ADDENDUM NO. ONE

FAIRFIELD COUNTY RECREATION, FIRE AND EMS STATION CAPITAL PROJECTS

FAIRFIELD COUNTY, SOUTH CAROLINA

DATE OF ISSUE: JULY 1, 2015

13C300

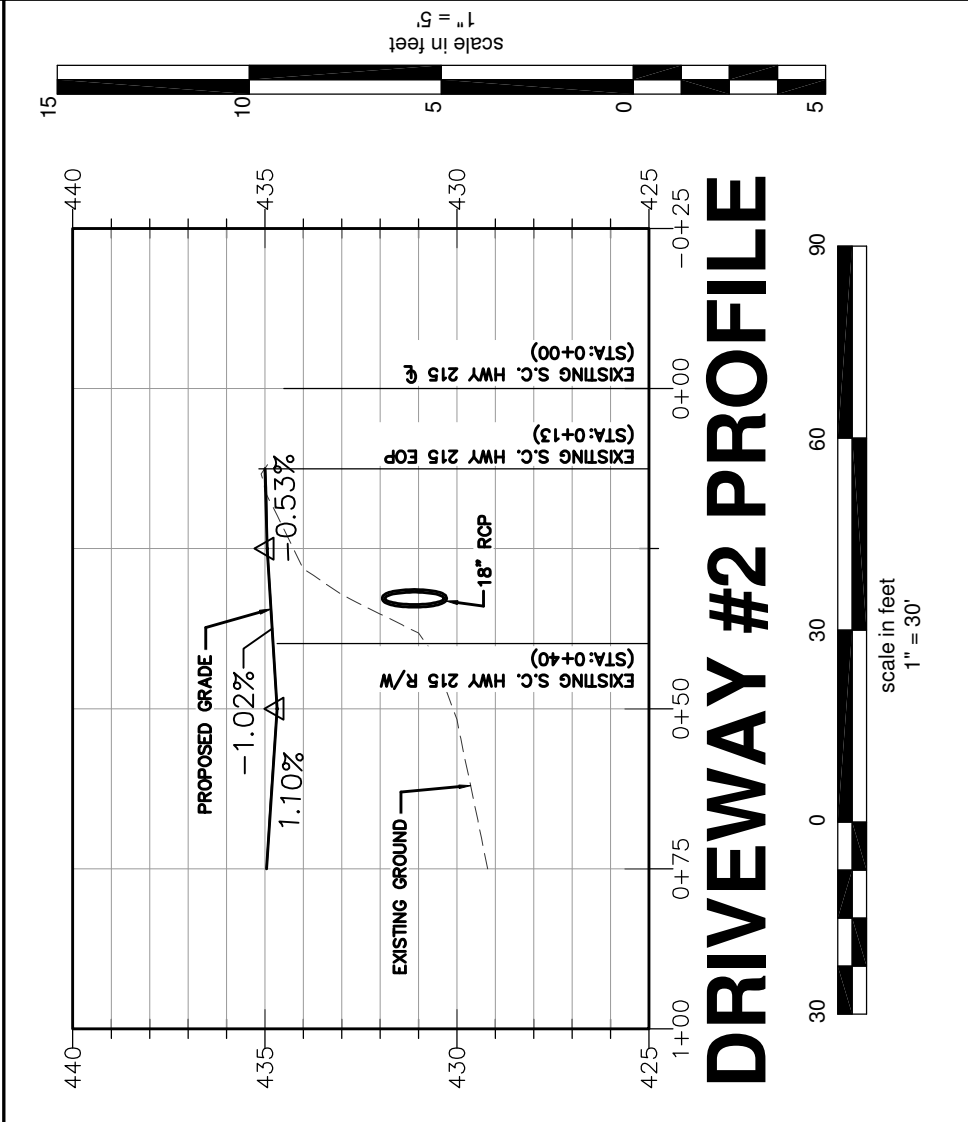
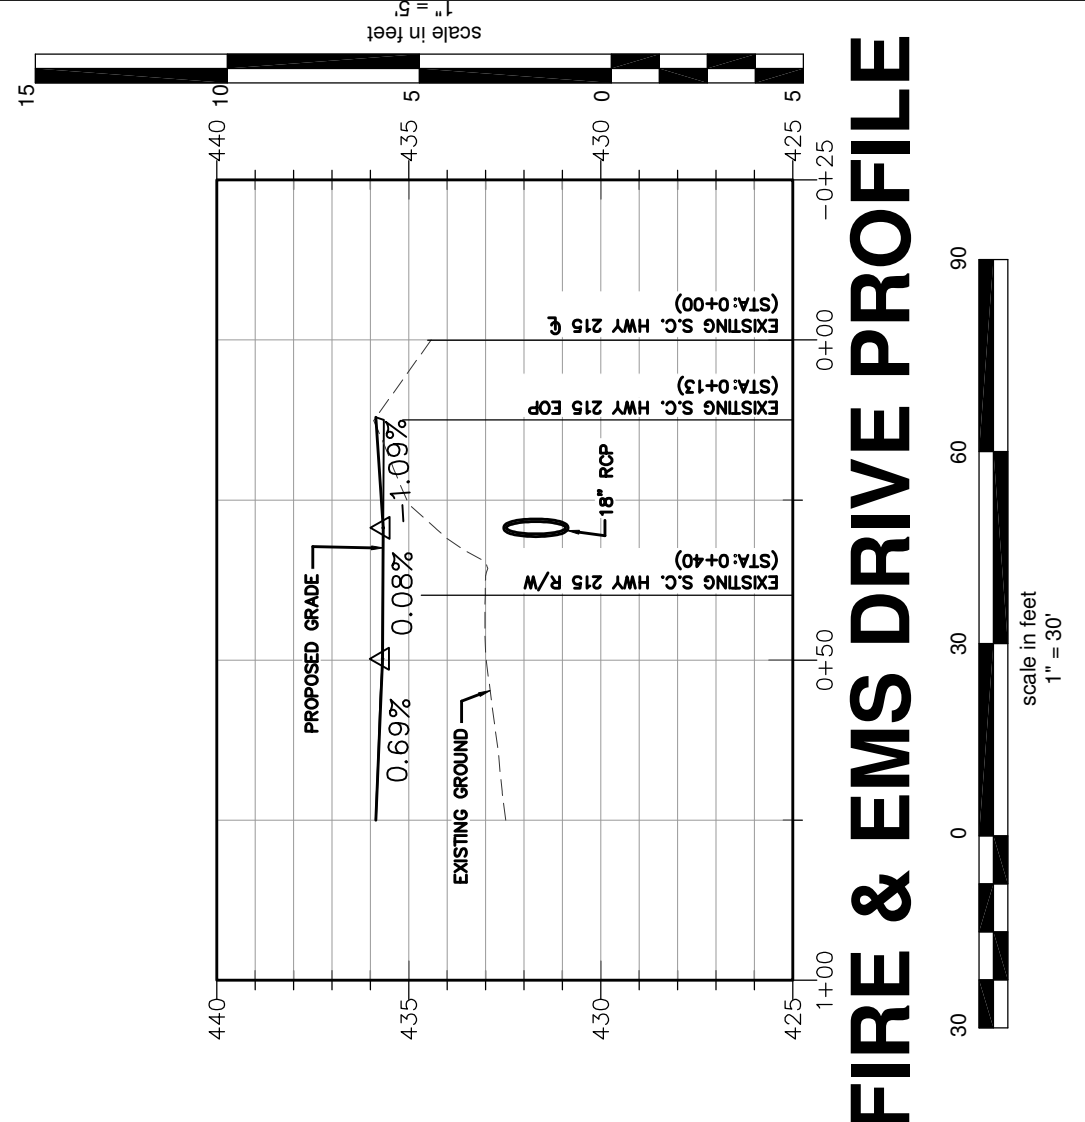
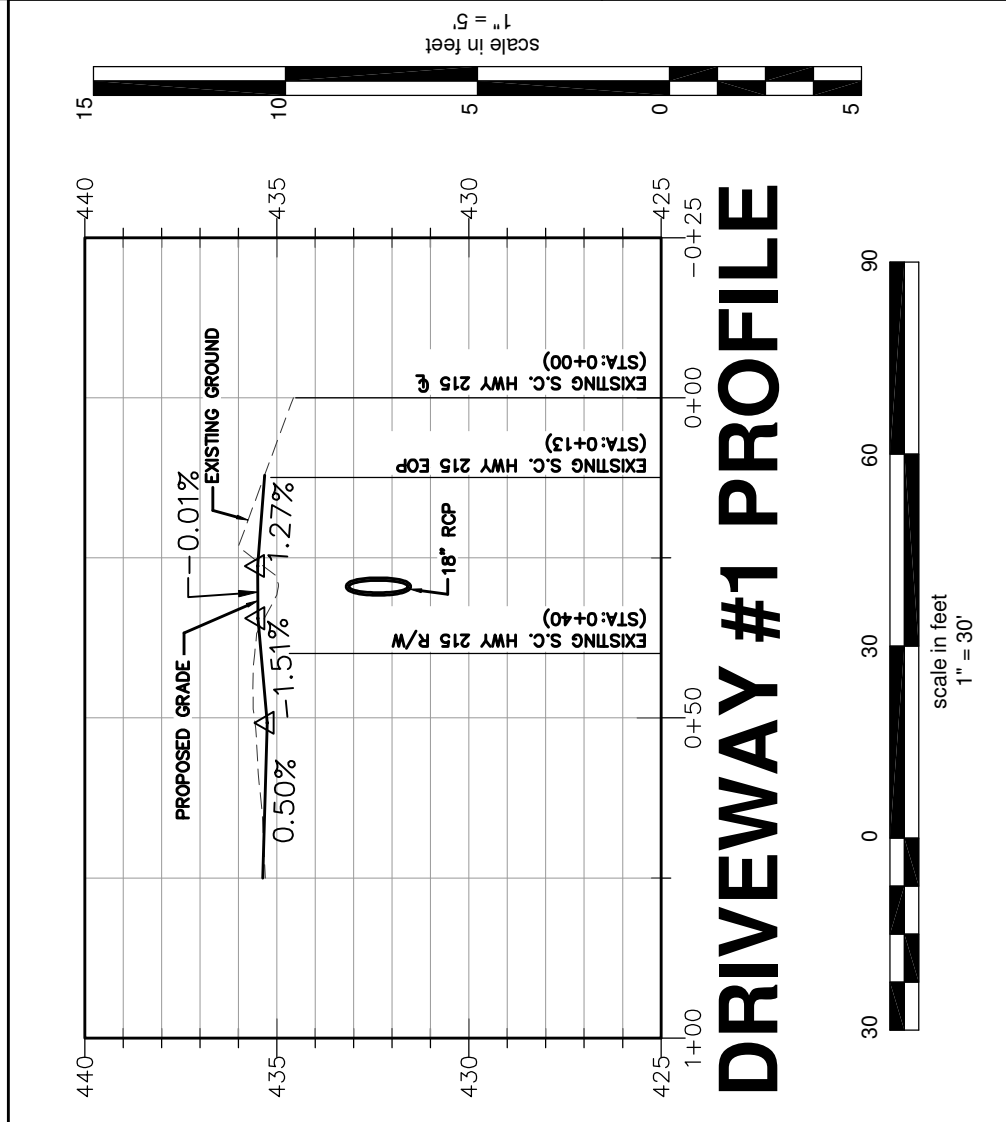
- Add the attached Sheet 1C300 Grading Plan-Smallwood
- Add the attached Sheet 13C300 Grading Plan-Jenkinsville Fire/EMS
- Add the attached Pedestrian Paving Detail LA_SK1
